DV16.129 - ATTACHMENT 1 of 3: LOT 501 (NO. 15) OMAROO TERRACE, CITY BEACH

Schedule of Submissions - Original Plans

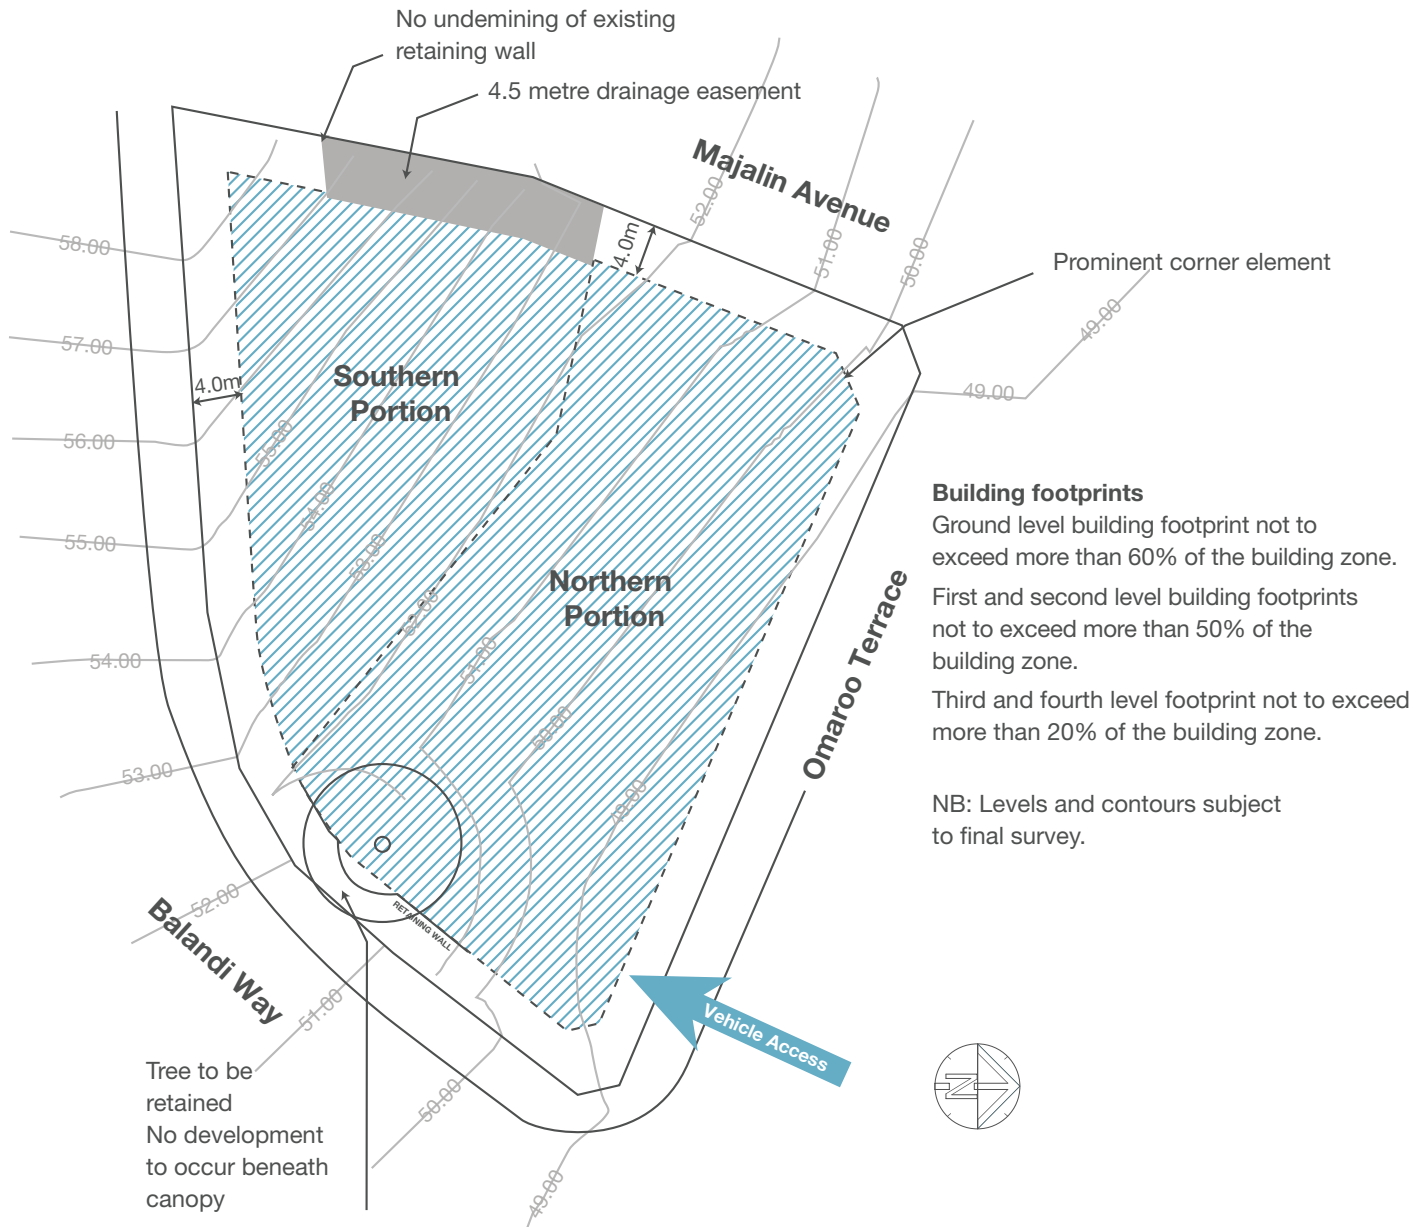
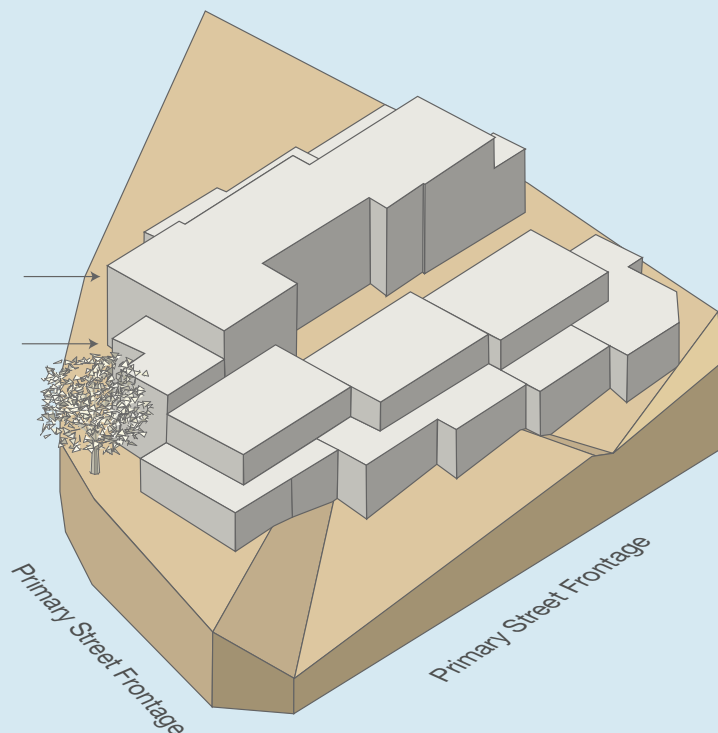
Ref	Submission
	<p>3. Reduced setback on Majalin Ave</p> <p>The setback on Majalin Ave is half what it is prescribed to be in the Guidelines (2m rather than 4m) and this adds to the inappropriate bulk of the building.</p> <p>4. Density and building design</p> <p>The Guidelines (page 28) state that the "proposed dwellings will be multi storey and will be stepped back into the existing topography, which falls dramatically to the north." (emphasis added). There is an indicative development diagram included on page 29. This proposal deviates in both of these elements, being basically three storeys straight up on the north face along Omaroo Terrace, and consisting of a large number of one and two bedroom single storey apartments.</p> <p>It is obvious from the Guidelines and the original advertising that development on these two sites (501 and 506) was envisaged to be entirely different from what is proposed here; 15-20 multi-level apartments on lot 501 and 11-15 on lot 506, rather than what is basically a block of flats.</p> <p>To comply with the R-Codes, a medium density development (R40, plot ratio 0.6) on this site could have 21 apartments maximum. This proposal is high density, with a plot ratio of 0.93, or R80 density- with 57% more dwellings than are allowable at R40. This is in distinct breach of statements in the Guidelines and advertising material that accompanied the sale of individual lots, and is completely out of keeping with the character of the area.</p> <p>Amenity issues</p> <p>This proposal is for a high-density apartment block with far more apartments than were envisaged, leading to the non-compliance with prescriptive elements described above. This large number of dwellings brings with it impacts on traffic movements, car parking provision and rubbish collection. The area is currently populated by many people with young families and has a very neighbourly feeling. These children run and play in the streets and in the park areas. A major increase in traffic, from 33 apartments, along with traffic associated from whatever is built on lot 506, will decrease this amenity very significantly and is a risk to the safety of these children.</p> <p>In summary, this proposal is for a high-density apartment block with nearly 60% more apartments than the maximum number that could be considered medium density, as specified in the Guidelines. In order to fit this excessively large number of apartments, the proposal is non-compliant, in a major way, with prescriptive elements in both the Guidelines and the R-Codes. This leads to a building of scale and bulk that was not planned for the site and a major detriment to the amenity and character of the area.</p>

5	<p>1 The Oceanmia Design Guidelines state on Page 29 that the upper roof level of the northern portion of the site shall have a maximum height of 59 metres AHD level. The upper roof level on the northern portion of the site appears to be greater than 59m AHD. It appears to be 59.22 AHD according to the North-East Elevation drawing.</p> <p>2 The Oceanmia Design Guidelines state on Page 29 that the upper roof level of the southern portion of the site shall have a maximum height of 66 metres AHD level. The upper roof level of the southern portion cannot be ascertained from the drawings and hence it is unclear whether it is compliant.</p>

Ref	Submission
3	It is not clear from the site layout plan whether the 4.5m drainage easement adjacent the retirement village is clear of development.
4	Layout 1 shows air conditioning condenser units positioned in the courtyard and visible from the street. This is not in line with the Oceanmia Design Guidelines nor good practice for a pleasant streetscape. It is strongly recommended that the project proponent be requested to relocate these condenser units to concealed locations or have aesthetic enclosures purpose built to conceal these units.
5	Dust generation will likely be an issue during construction for residents in the Oceanmia Estate. It is suggested to the Town of Cambridge that a condition be placed on the Building Contractor to develop, submit and have approved by the Town of Cambridge before site works commence a Dust Management Plan detailing how dust will be managed and suppressed to avoid impacts to existing occupied homes and residents.
